Customer	: CU-DAR001 Dart Helicopters Services	Drawing Name	: HELI UTILITY BASKET LH/RH 350/355
Job Number	: 48300		
Estimate Number	: 10208		
P.O. Number	:	Part Number	: D350607043
This Issue	: 29/05/2009	S.O. No.	:
Prsht Rev.	: NC	Drawing Number	: D350-607 REV F P7-9
First Issue	: 29/05/2009	Project Number	: N/A
Previous Run	: 48299	Drawing Revision	: F
Written By	:	Material	:
Checked & Approved By	: <u>Julie Dawson 05.29</u>	Due Date	: 08/06/2009
Comment	: Est Rev:E as Per DSI9318 06-01-24 JLM	Qty:	1
	Est Rev:F ECN1068 07-12-21 DD verified by:	Um:	Each

DESIGN <i>CP</i>	DRAWN BY <i>CP</i>	DART AEROSPACE LTD HAWKESBURY, ONTARIO, CANADA	
CHECKED <i>HH</i>	APPROVED <i>HH</i>	DRAWING NO. DSI 9318	REV. A SHEET 1 OF 1
DATE 06.01.06		TITLE WASHER ADDITION	SCALE NTS
A	06.01.06	NEW ISSUE

DART SERVICE INSTRUCTION

TO AMEND INSTALLATION INSTRUCTIONS D350-607 REV. F

Figure 5- Basket Replacement Parts
(D350-607-043 Heli-Utility-Basket™)

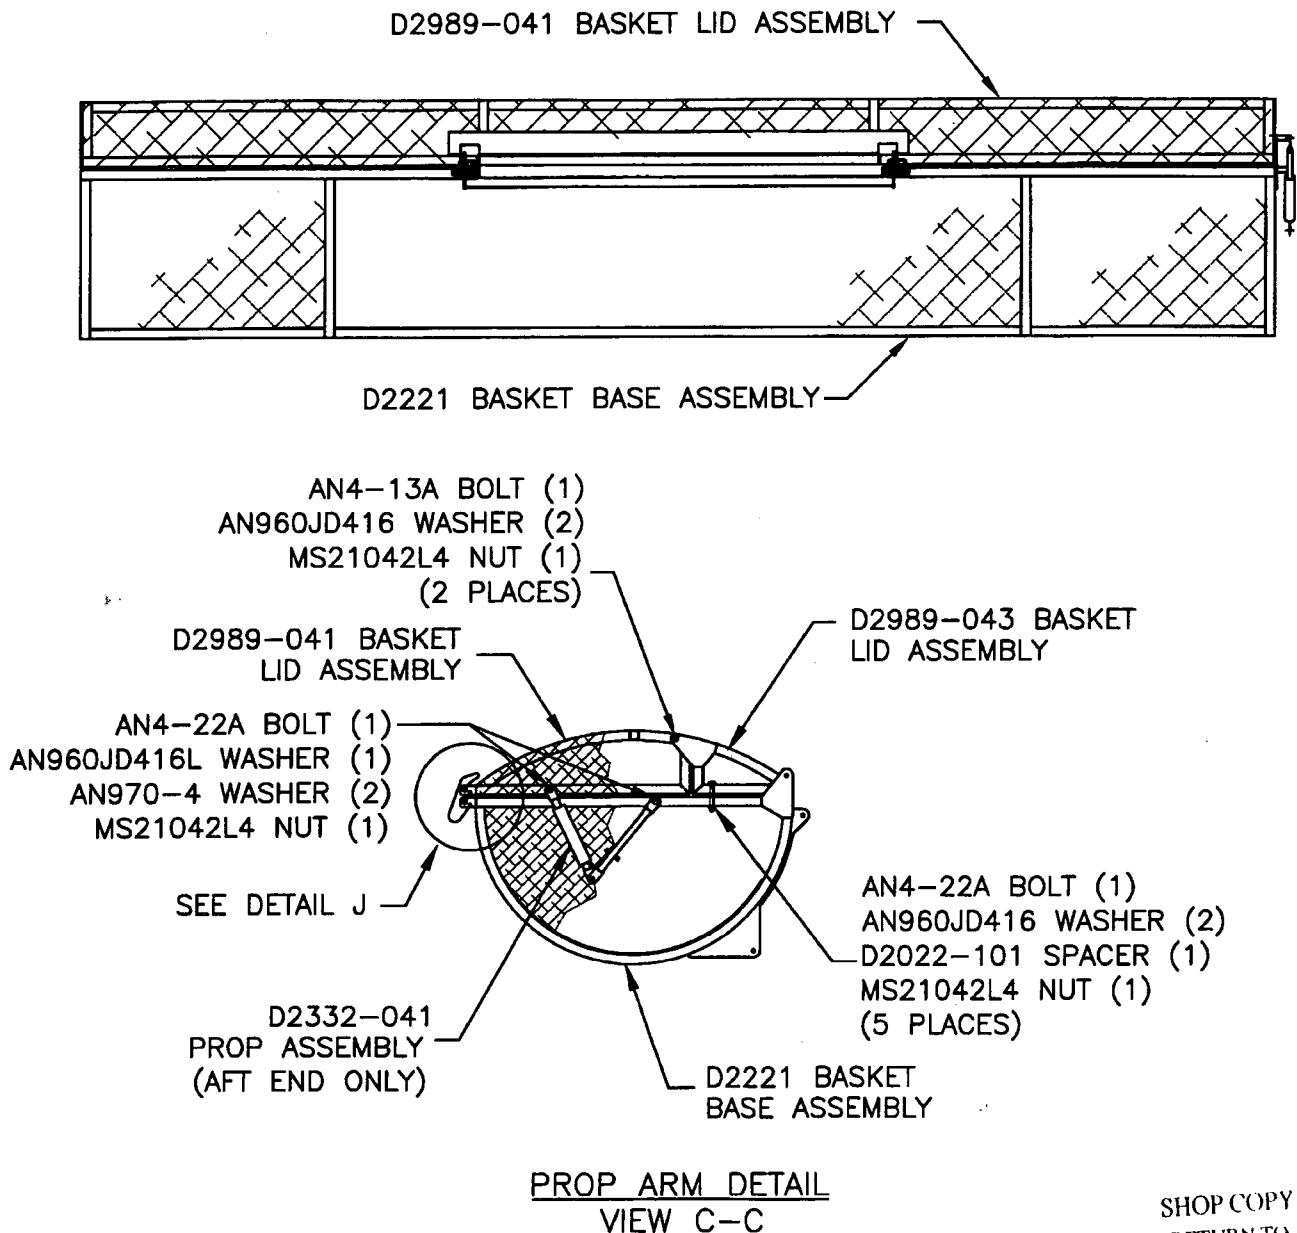
To reduce the possibility of damaging the finish, a **NAS1515H4** washer (2 places) has been added between the hinge plate and basket frame on the **D350-607-043/-047 Heli-Utility-Basket**.

The corrected bolt stackup from Figure 5 of installation instructions D350-607 Rev. F is given below:

AN4-13A BOLT (1)
AN960JD416 WASHER (1)
HINGE PLATE (REF)
NAS1515H4 WASHER (1)
BASKET FRAME (REF)
AN960JD416 WASHER (1)
MS21042L4 NUT (1)
(2 PLACES)
